Letter of Objection to the development at Former Tower
Car Sales, Tower Close, East Grinstead, West Sussex
(now known as Whittaker House, 1 Leppard Walk) and
retrospective application DM/26/1449

Appendix A – original letter of objection for **DM/26/0432**

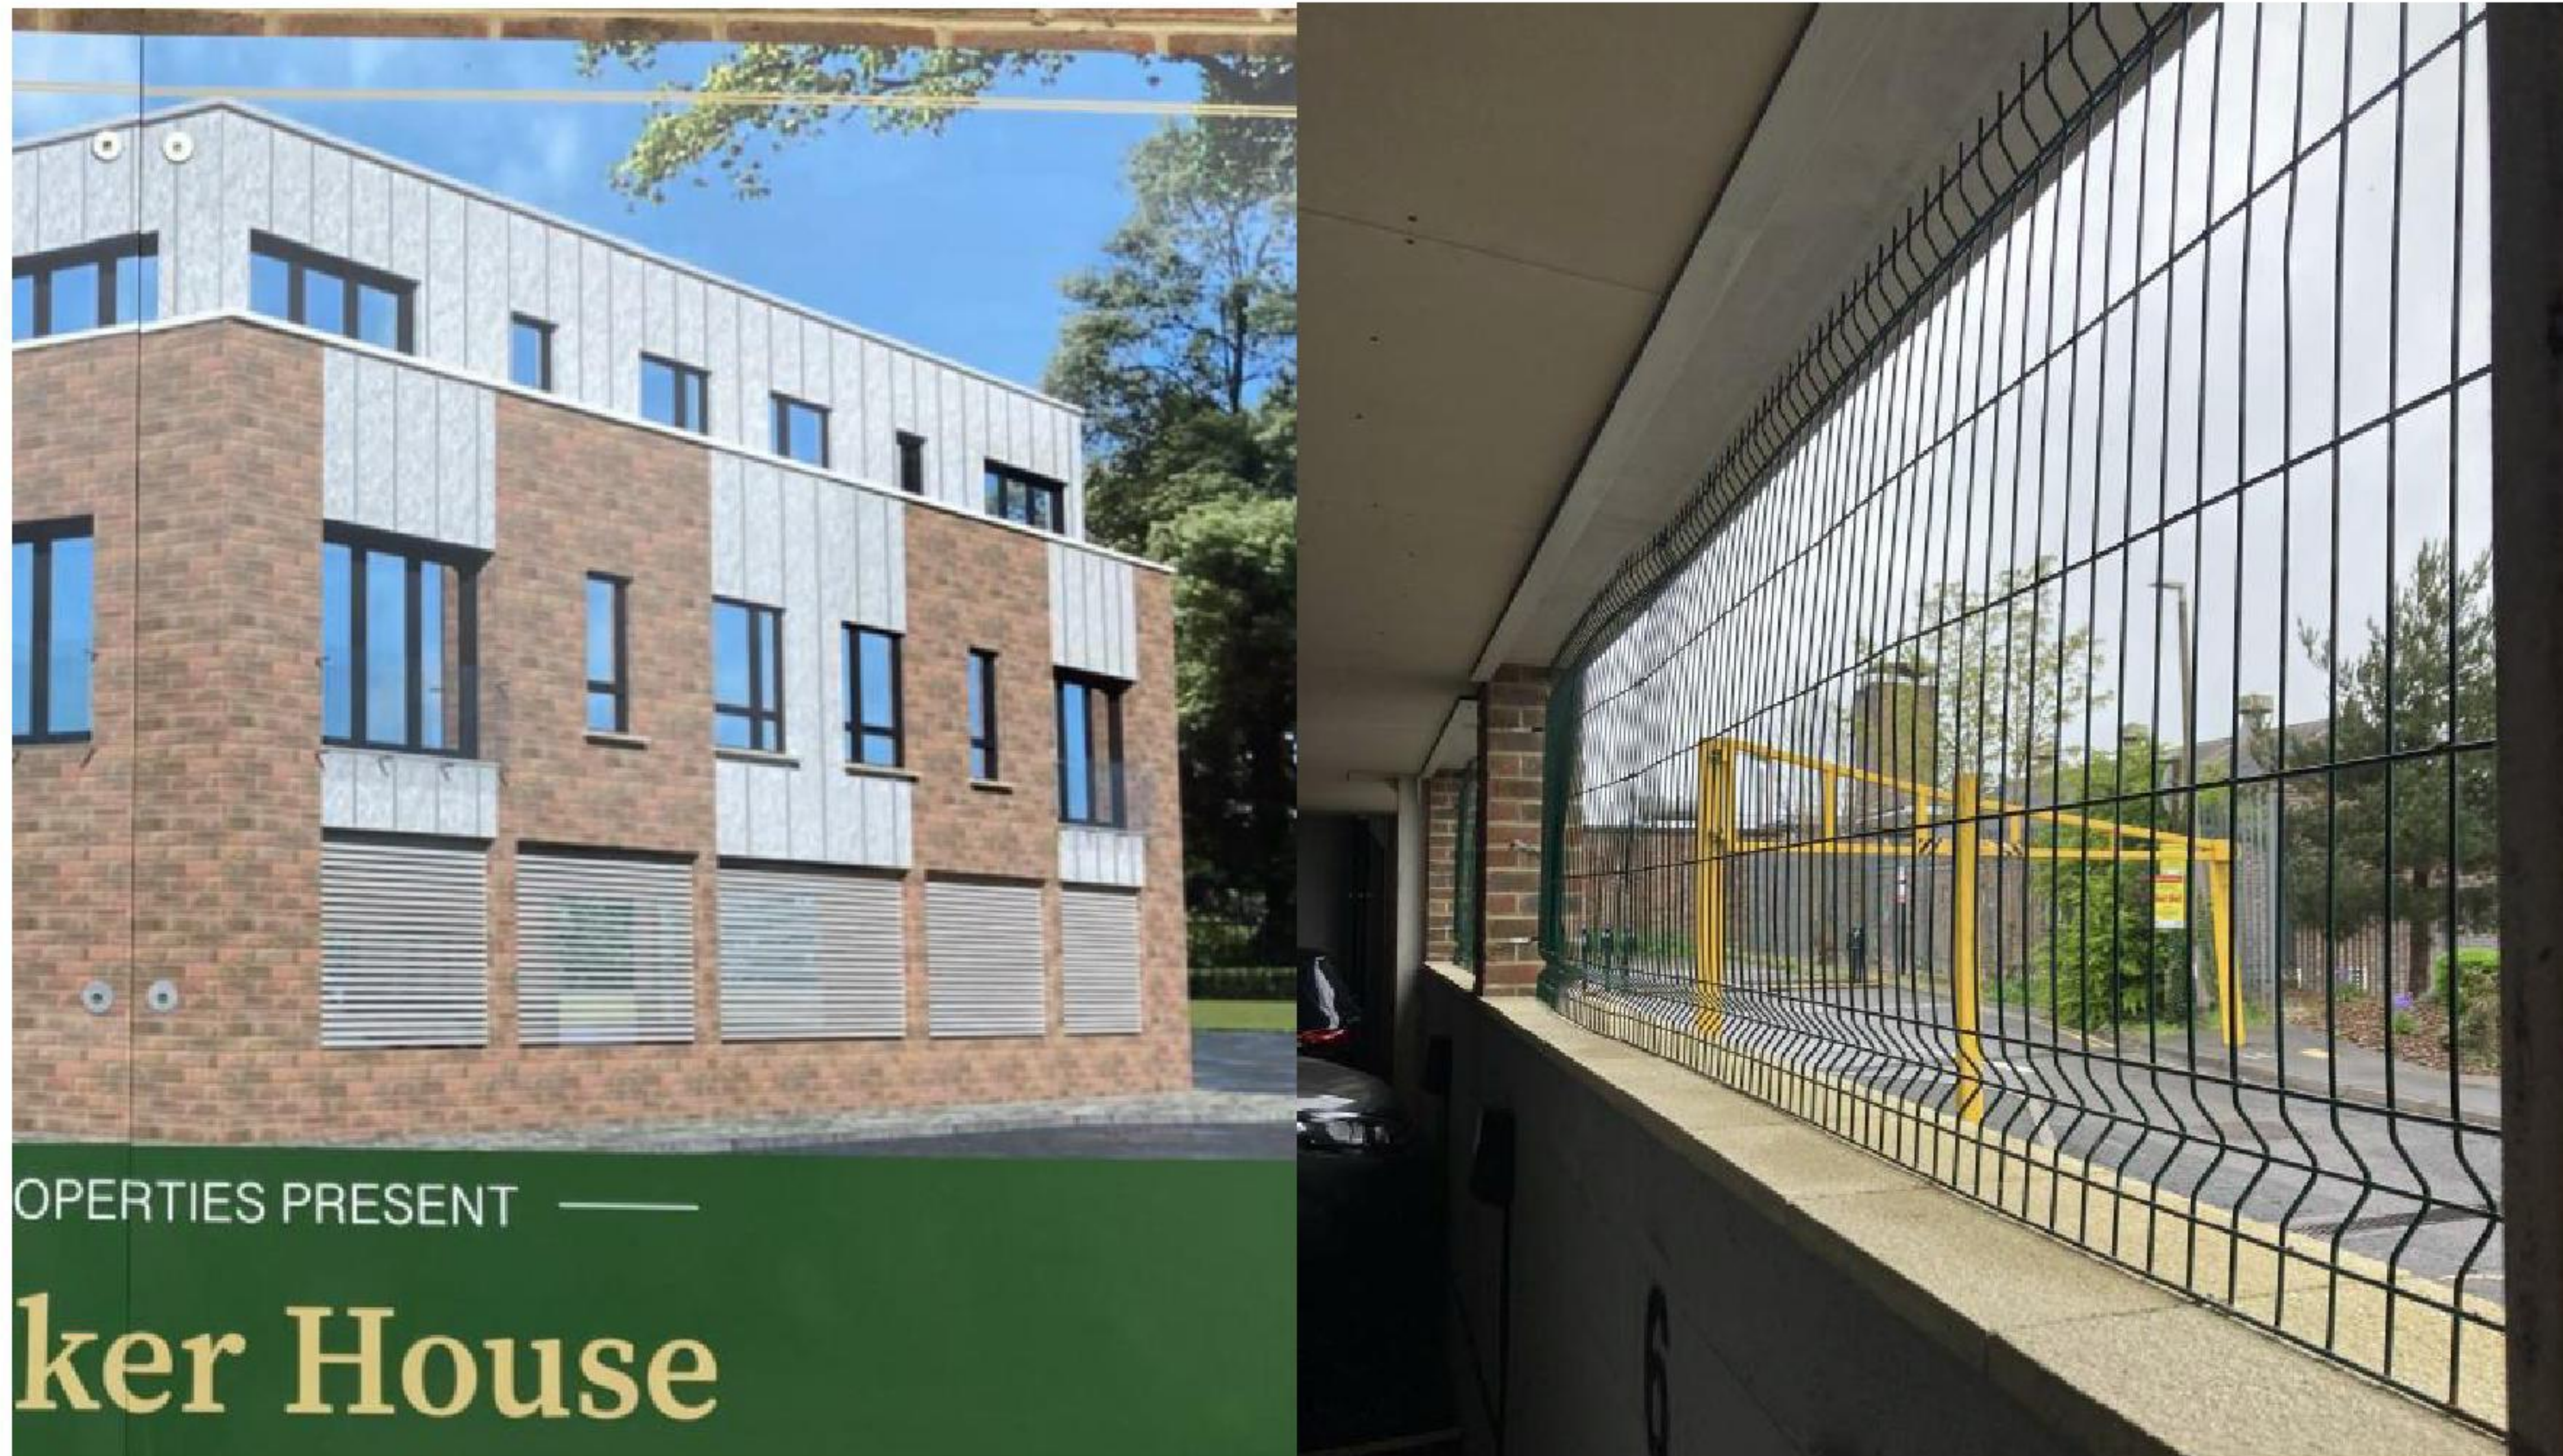
Planning permission for Whittaker House was granted on the expectation that residents would not need to enter through the undercroft, and they would have a dedicated entrance. This has also been sacrificed to make room for a potential 10th flat, with the entrance now located within the undercroft. None of the entry systems, neither internal nor external, have ever worked. The developer has been reached out to numerous times to correct this, but as of writing, no one in Whittaker House is able to receive guests, or secure deliveries, without either getting telephoned first or waiting outside the property. This is yet again more proof of the developers lack of character, and the disparity between what both we and the Planning Office were sold versus what was delivered.

The opaque glass has now been replaced with a back door, which accesses the bin and bike storage and takes us past Flat 1A's front door. The area under the stairs, which was supposed to be our hallway through to a front door, is now the cupboard where all our meters are stored. Further proof that the developer had no intention of building to plan, permission, or sales materials:

The sales poster for Whittaker House (also submitted in plans); The current car park grills

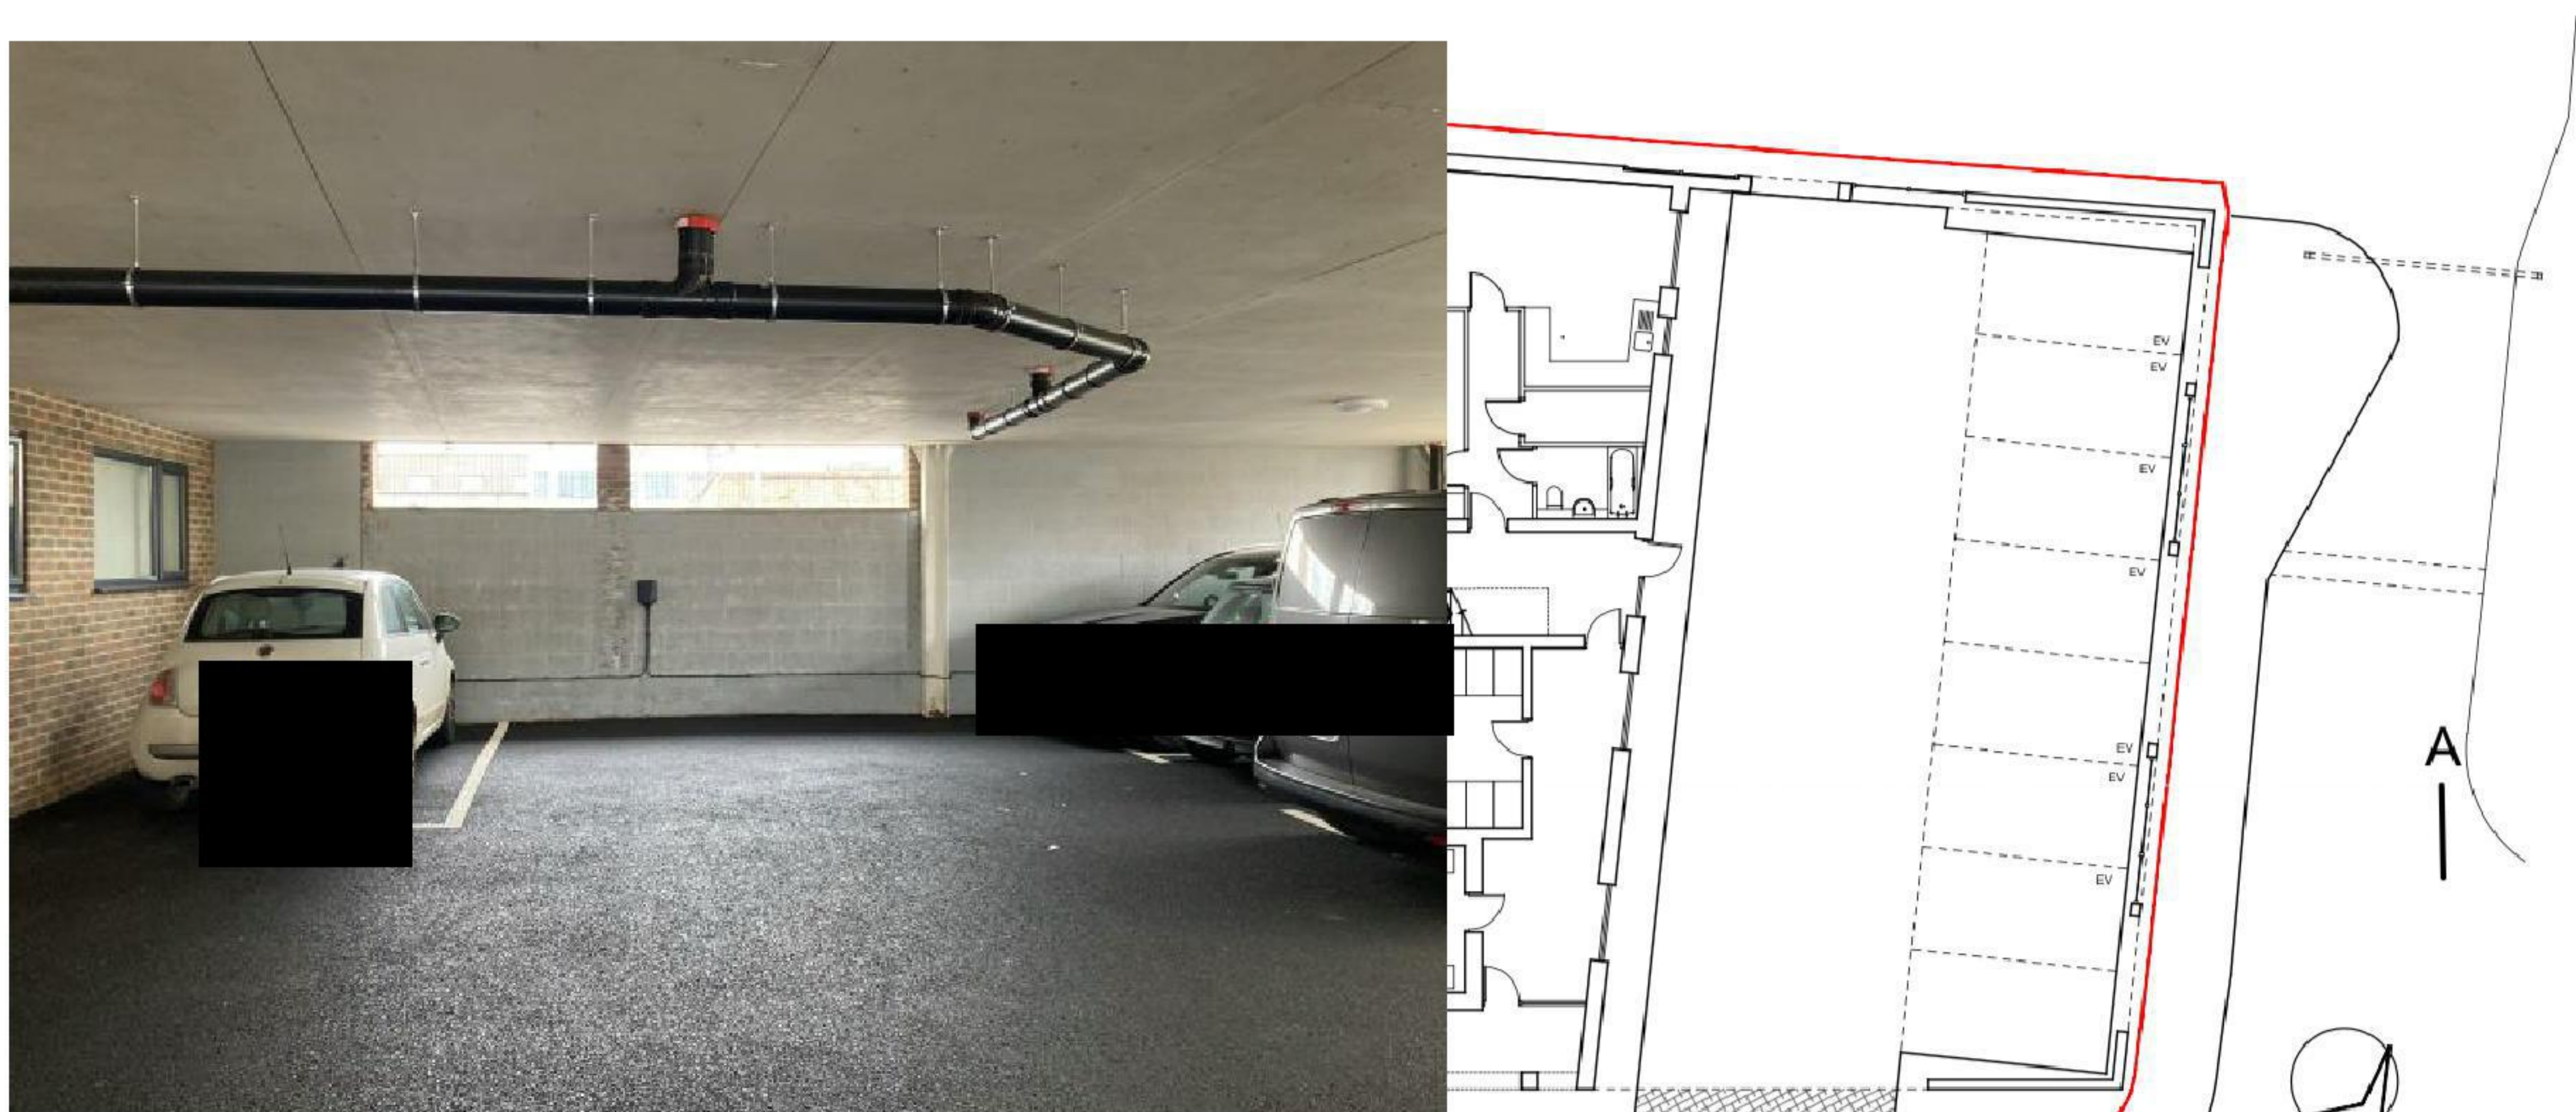
This was originally designated for 8 parking spaces, with tasteful exterior slats (or filigreed metal screens, depending on the submitted pictures). What we have been given more closely represents a snipers nest in Fallujah. This has a considerable effect on the exterior appearance of the building, and combined with the new front facing refuse area, significantly lowers the appearance of the neighbourhood:
